U.S. NUCLEAR REGULATORY COMMISSION

Report No. 50-282/306-OL/8601

Facility Name: Prairie Island

Examination Summary

Figure 1.03 (QUESTION)

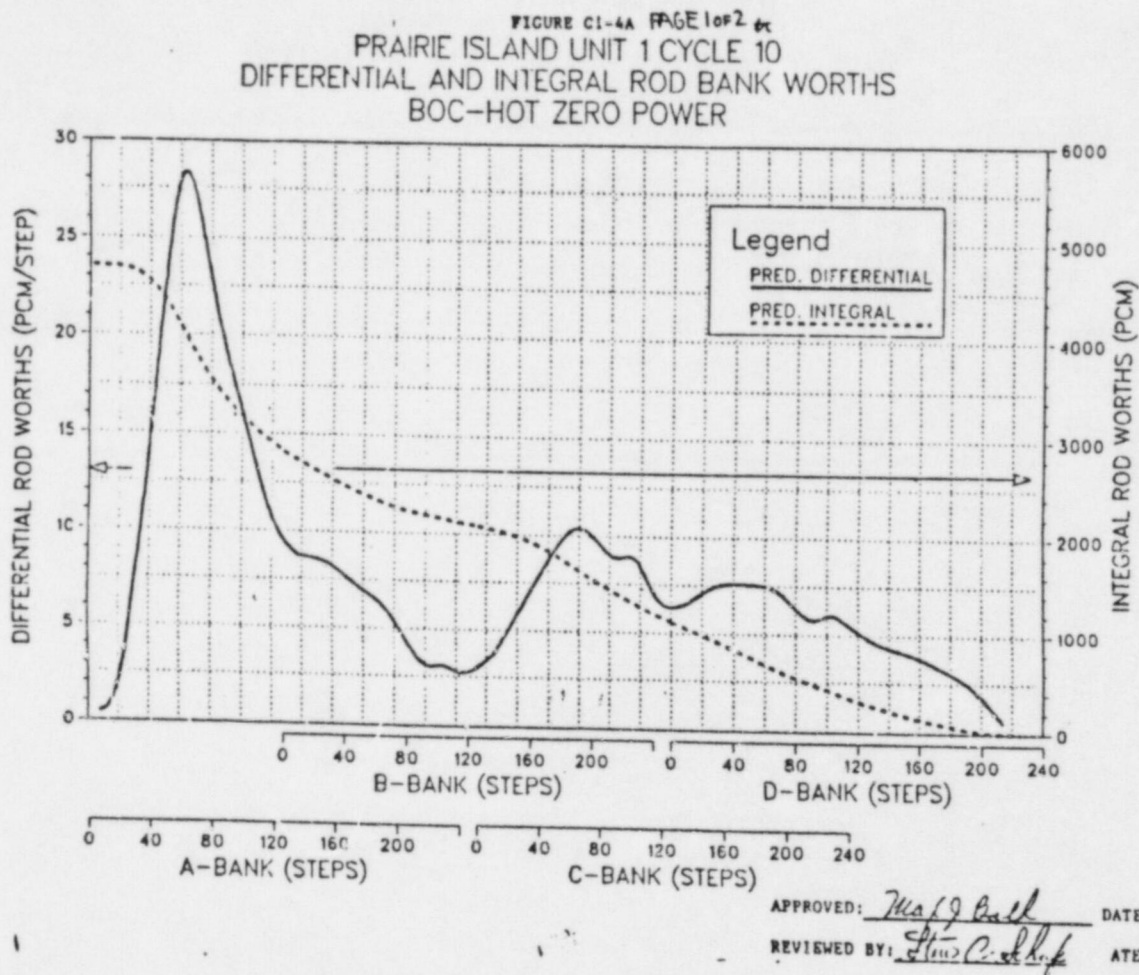
Key requires answer to be within ± 5 steps. Smallest scale division for rod height is 40 steps, accuracy required should be ± 20 steps (one-half scale division).

Figure 2.02 (QUESTION)

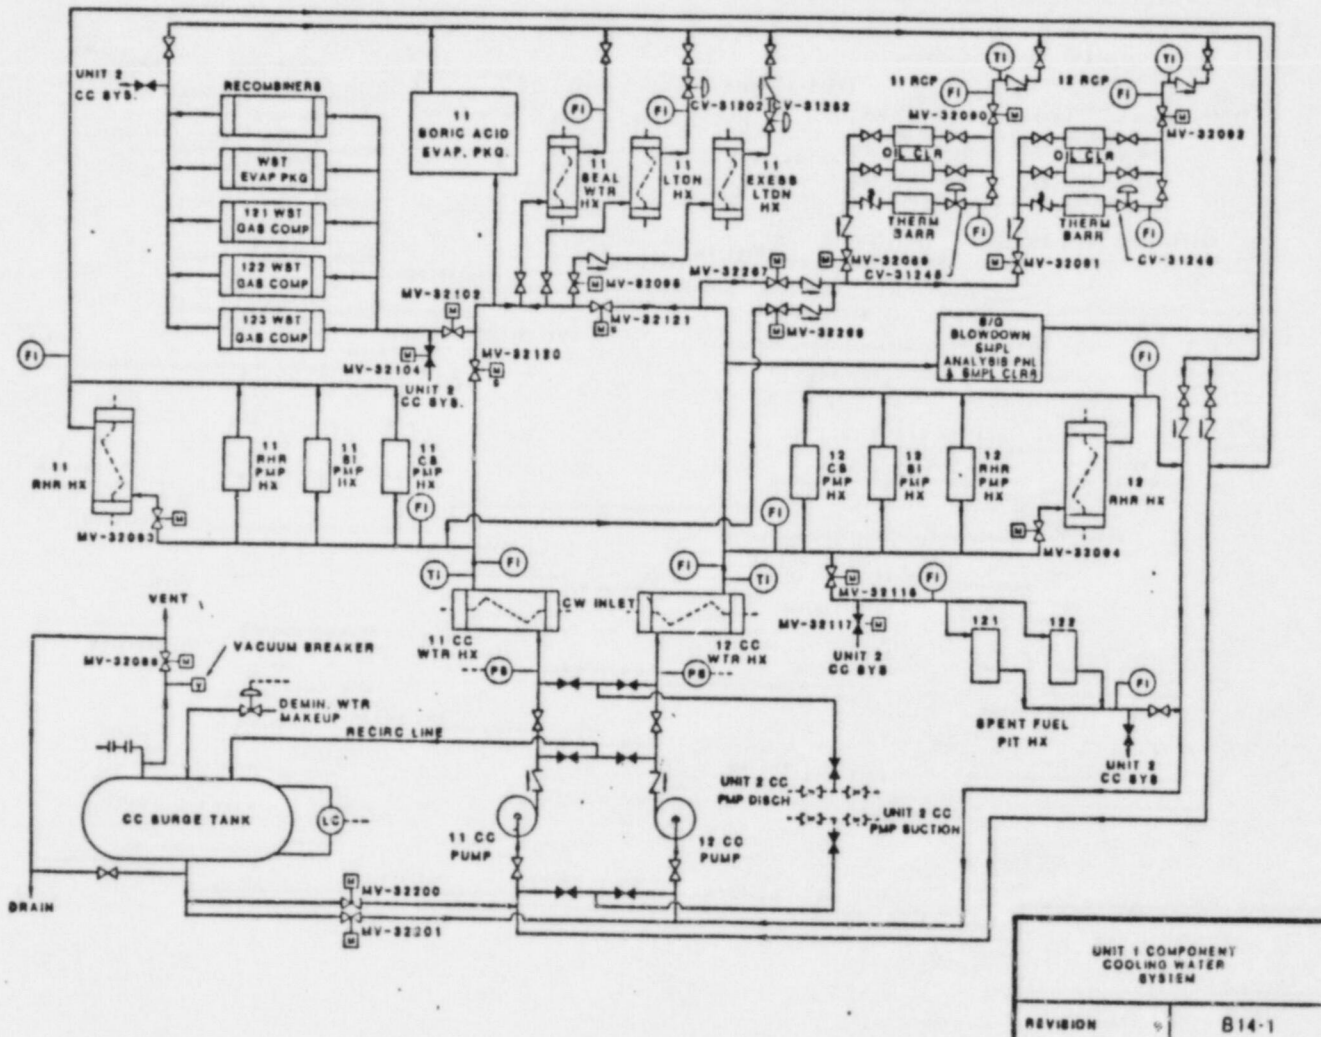
Question specified listing of components. During exam, the proctor authorized circling items on drawing which should be acceptable.

Notes comment

Figure 2.04 (QUESTION)

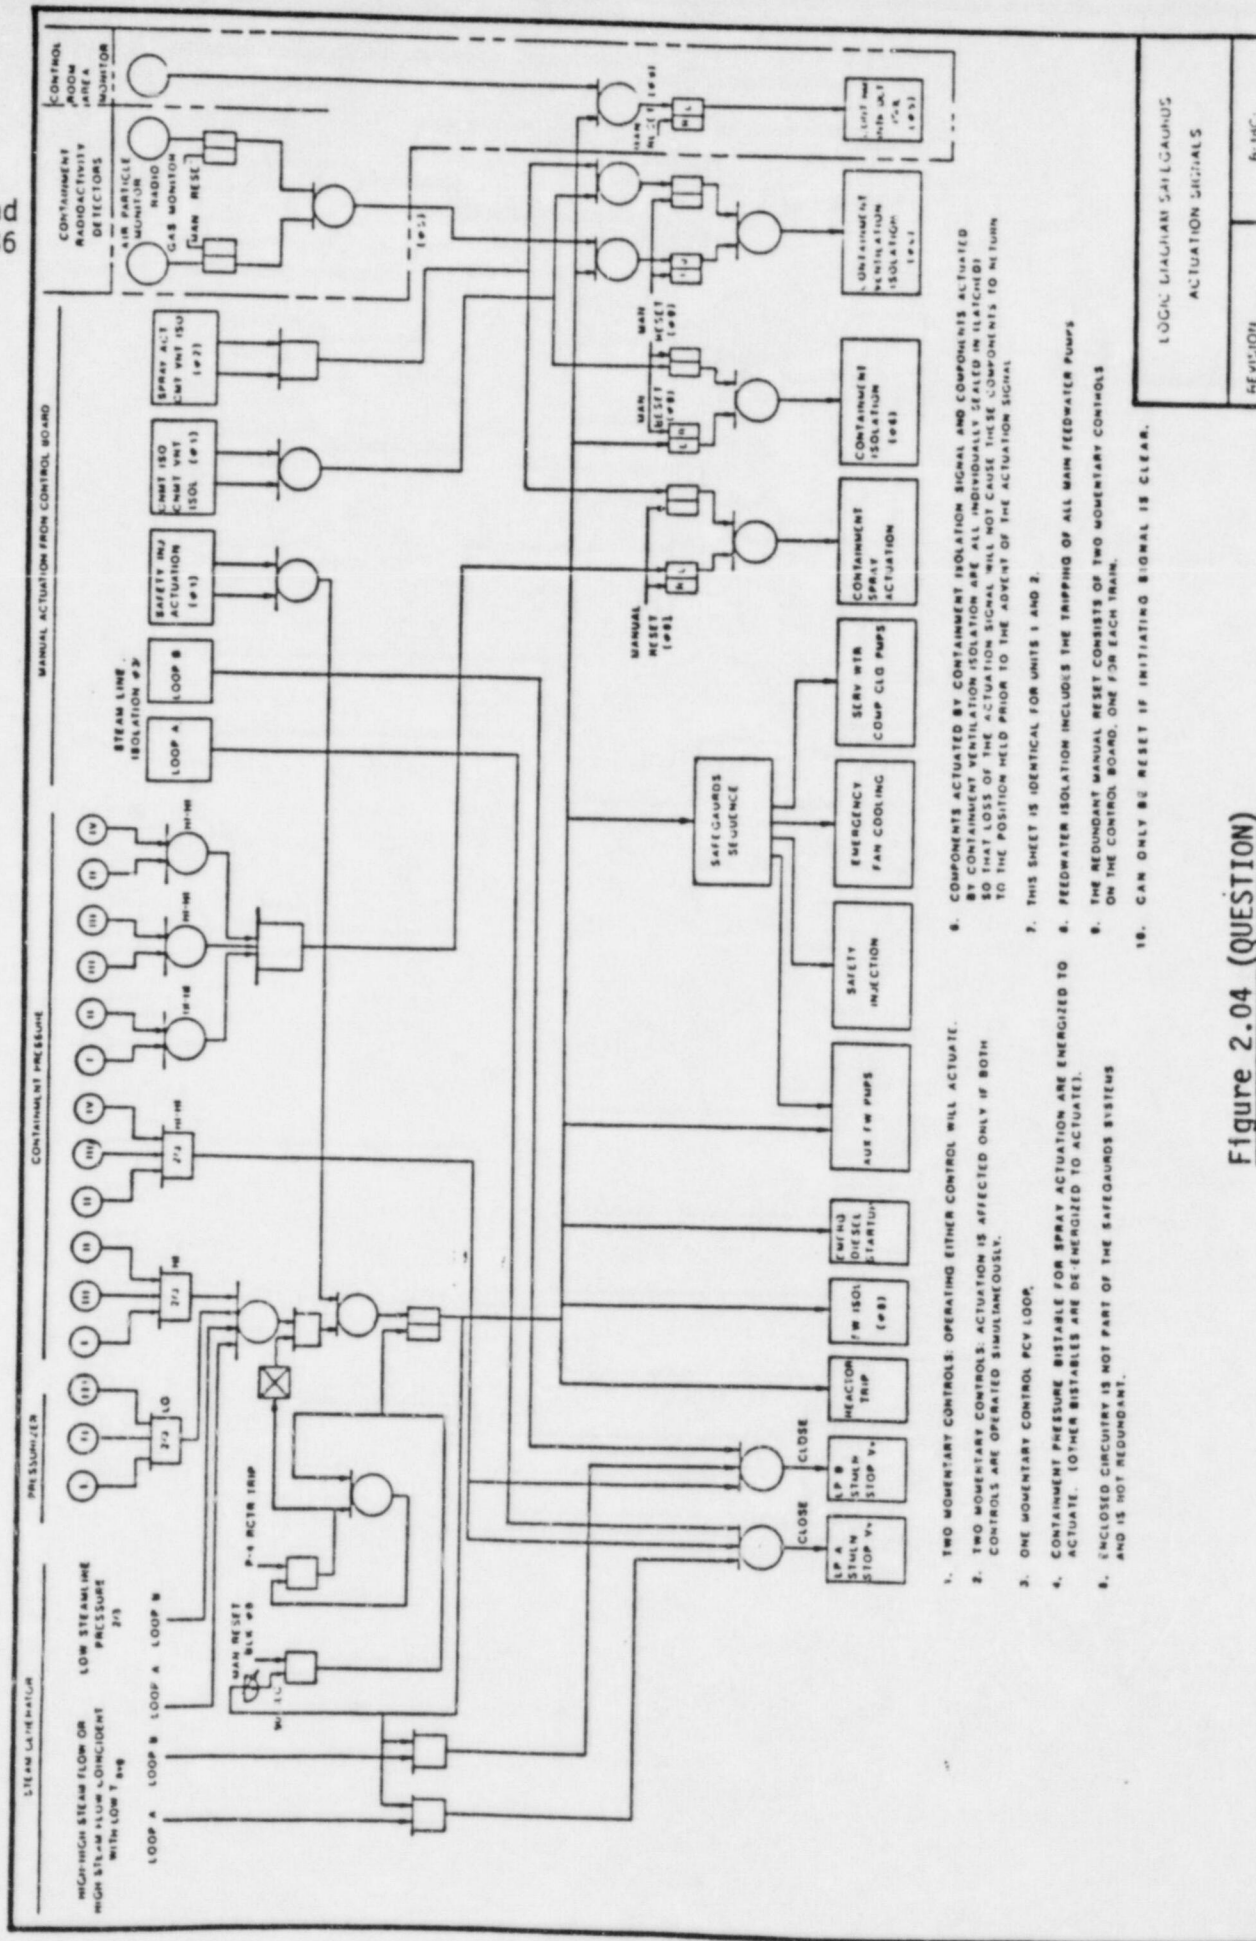
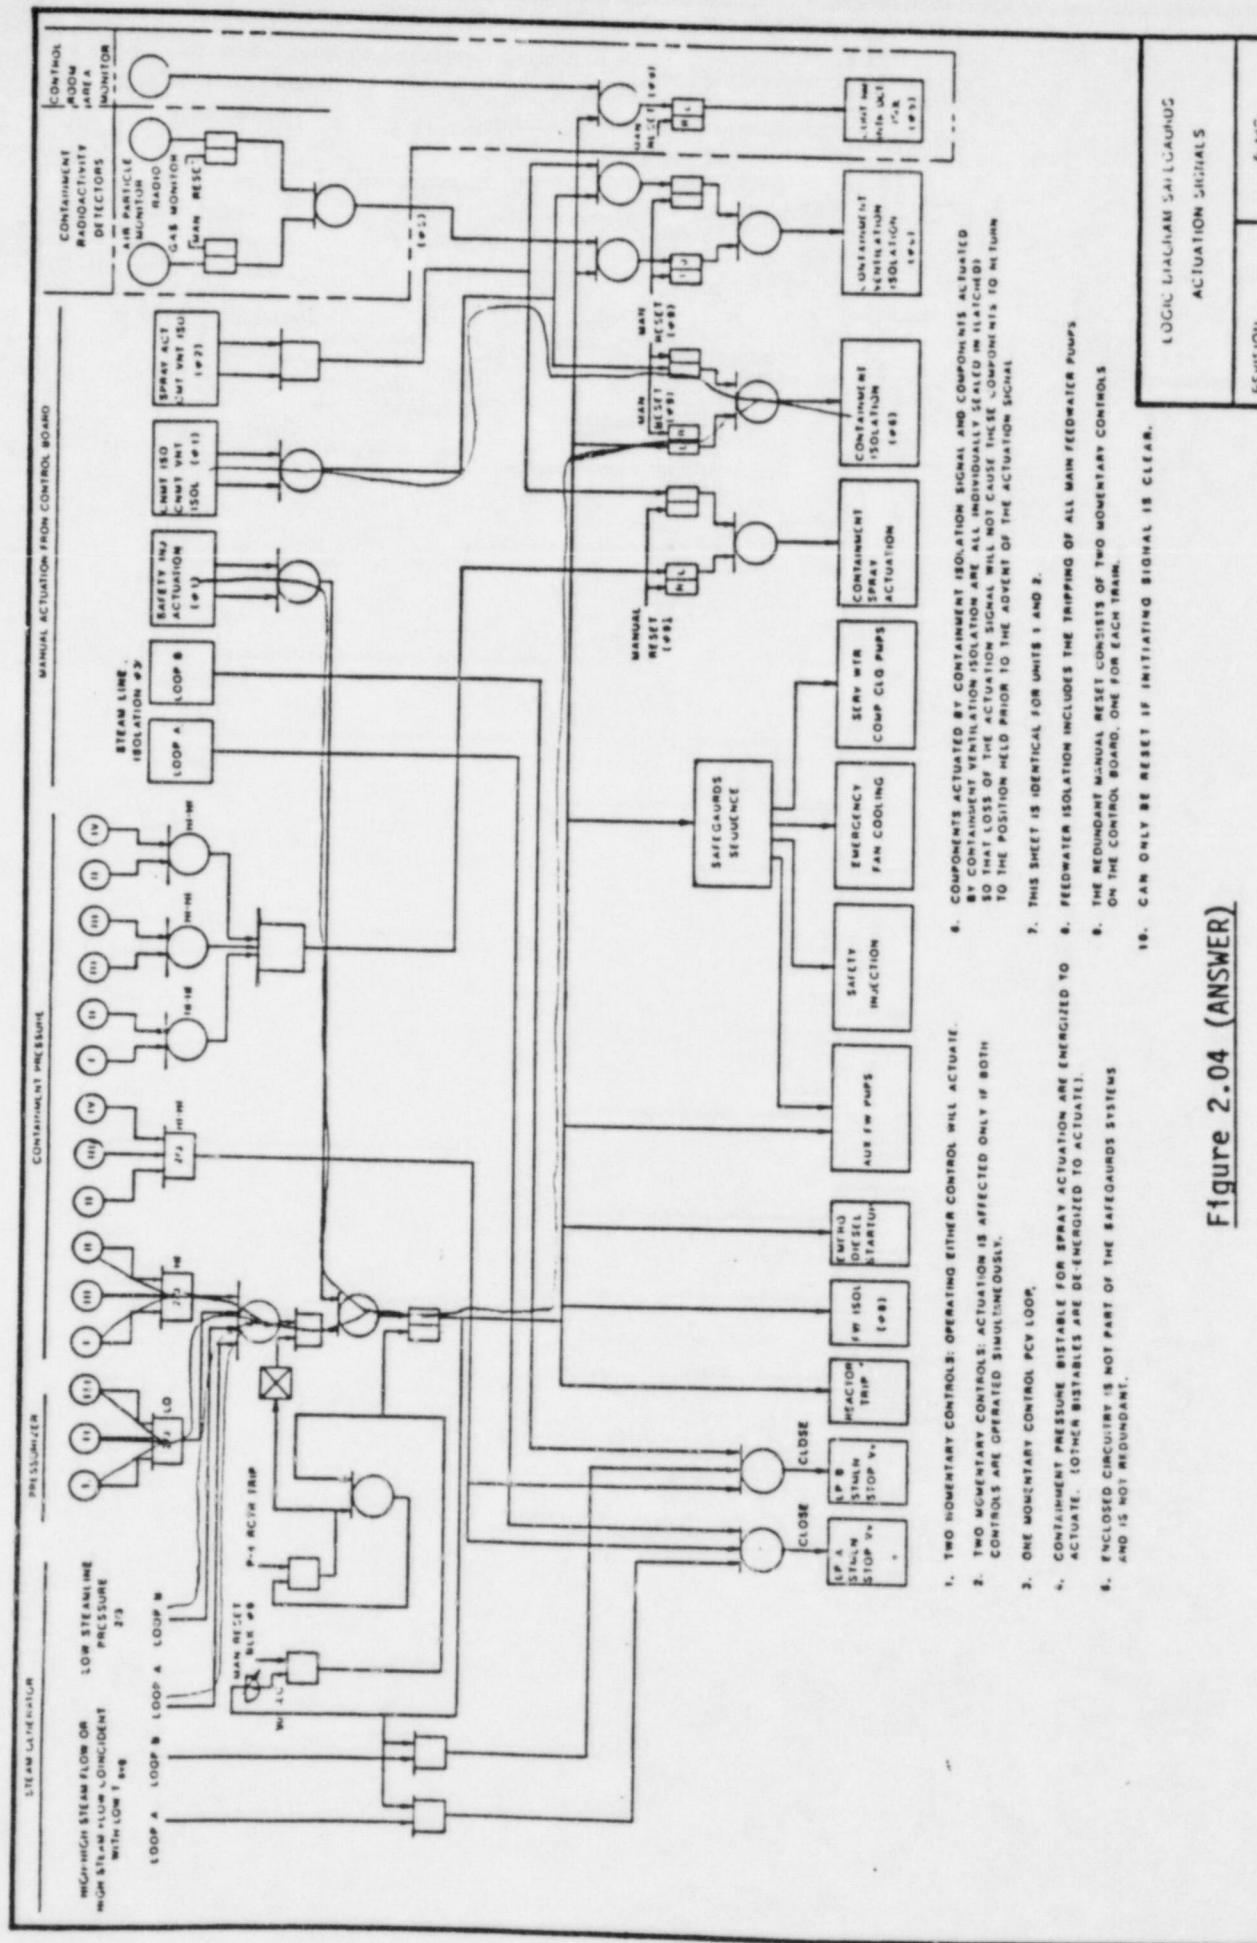
Question does not specify how many responses are required. Credit should be given for tracing back to an initiating signal, even though 10 inputs may not be indicated.

Figure 3.09 (ANSWER)

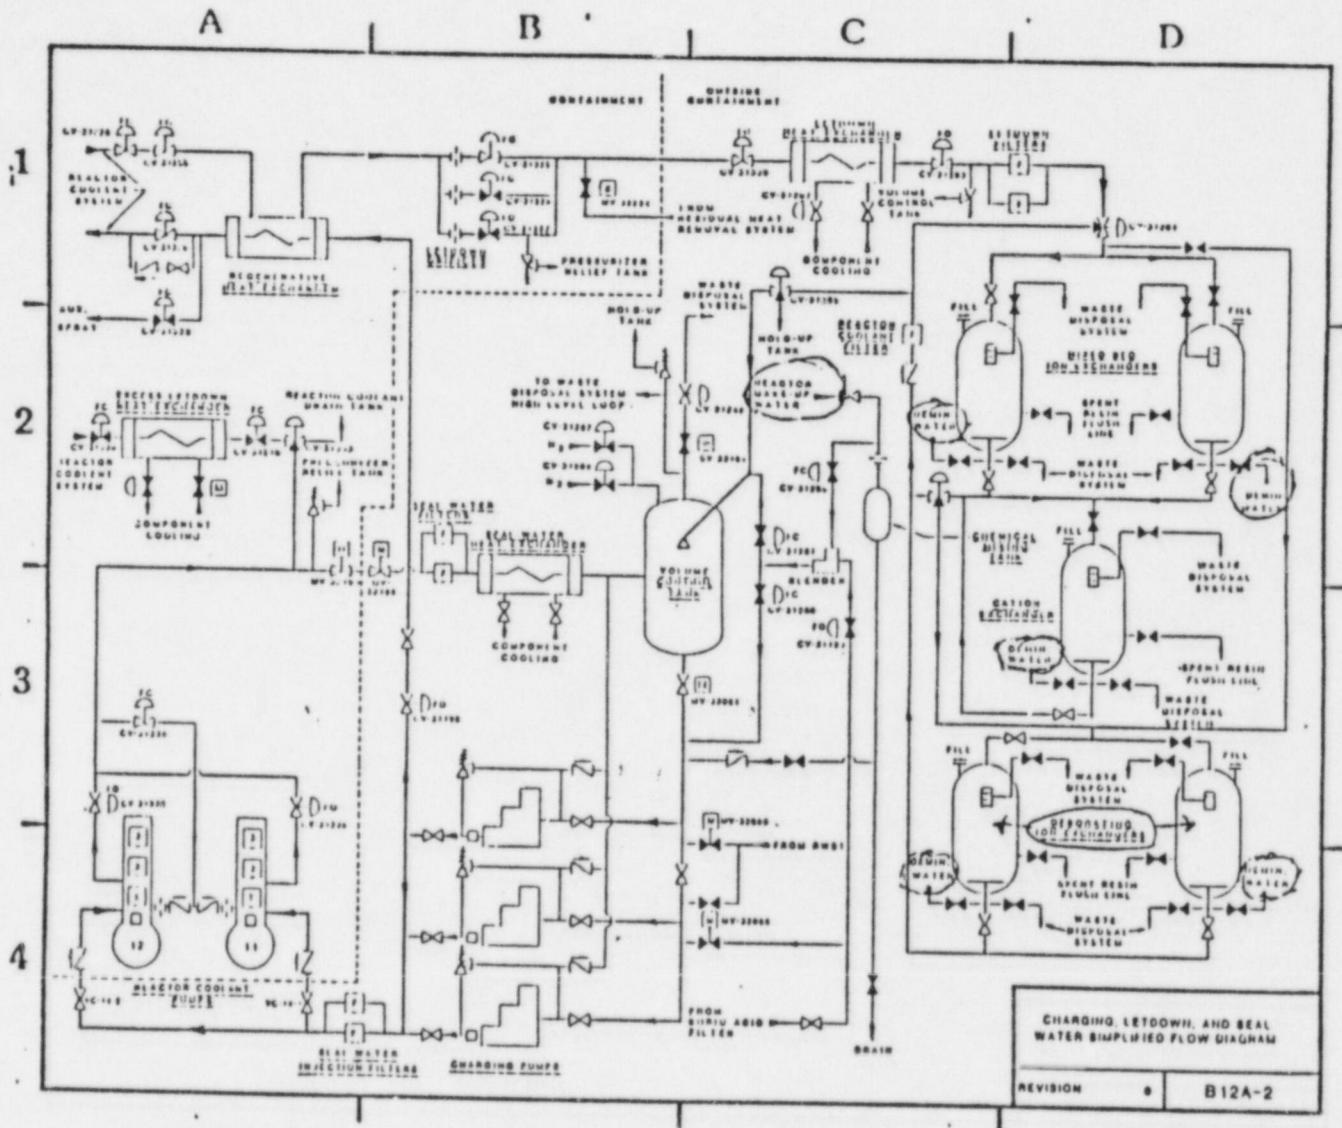
Question says to "identify" potential sources of inadvertent dilution. Listing of sources should be acceptable in addition to marking drawing. In addition, there are two separate paths for Reactor Makeup, through blender and through chem mix tank. Both paths should be acceptable. Also, a likely source of an inadvertent dilution is placing a new mixed bed demin in service that is not saturated.
